Zoning Board of Appeals

Staff Report

Re: Comprehensive Permit application for the Cloverleaf project at 22 Highland Road

Re: *Cape Cod Commission Staff Comments*
“Cloverleaf” 40B/ Comprehensive Permit Application, 22 Highland Road, Truro
Community Housing Resource, Inc./ Ted Malone

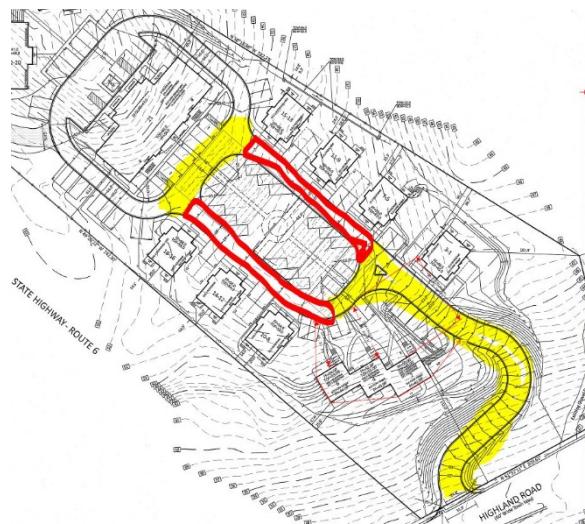
- The required site drive widths are provided through most of the site. The image shows the areas that require 20' width in yellow, with areas that can be narrower for one-way traffic in red. The 20' width should be extended an additional 10' to the west in front of Unit 6. The state officials added arrows that point to the limits of the required 20' way.
- Turning radii for emergency vehicles will have to be examined.
